Issue Date:	September 19, 2024	File No.:	mem_2024.01
To:	Cimir Bains, P.Eng., PMP	Previous Issue Date:	September 03, 2024
From:	Joey Balko, P.Eng.	Project No.:	2019-3623-00
Client:	Blatchford Renewable Energy		
Project Name:	Blatchford DESS		
Subject:	COE-IM-TMO-0005 - Blatchford District Energy Sharing System - Design & Construction Guideline Amendment

1 **TYPICAL DETAIL** NTS
PULL BOX WITH DRAIN

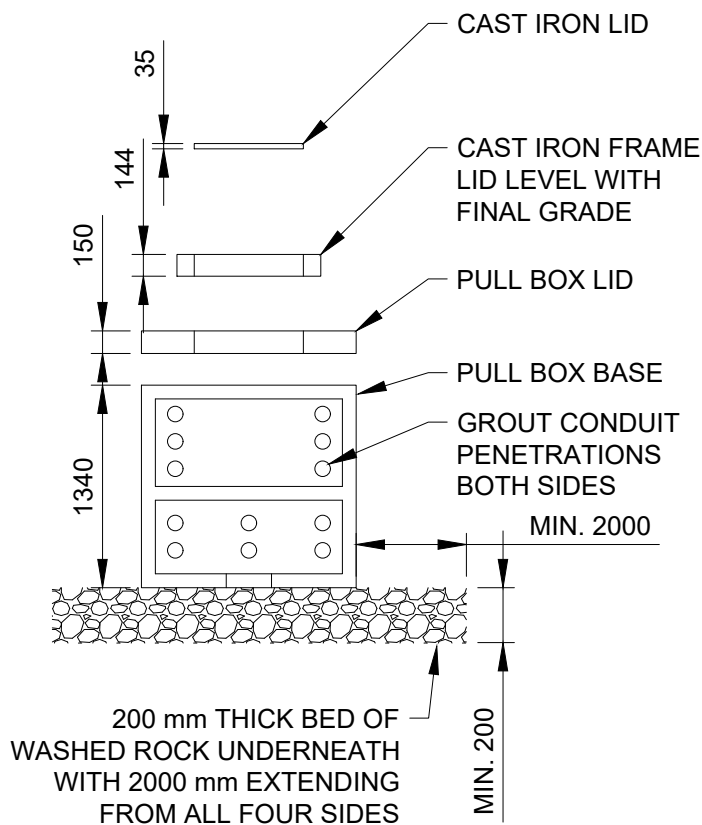
The following detail enclosed shall be added to the guideline details:

- E-02 – Electrical Pull Box Detail with Drain

- .1 Open Bottom Pull Boxes and Closed Bottom Pull Boxes (Vaults):
 - .1 Shall be Placed on 200 mm crushed washed rock. Washed rock at the base of the pull box shall extend a minimum of 2000mm in all directions around the pullbox.
 - .2 Closed Bottom Vaults shall have a minimum 50mm drainage hole in bottom of the vault to allow water to drain freely.
 - .3 Conduits in the pull boxes should be sealed in accordance with specification 33 65 76 Direct Buried Underground Cabling Ducts.
 - .4 Lid at finished grade.
- .2 Pedestals:
 - .1 As per Detail E-01 – Typical Junction Pedestal Elevation Detail.
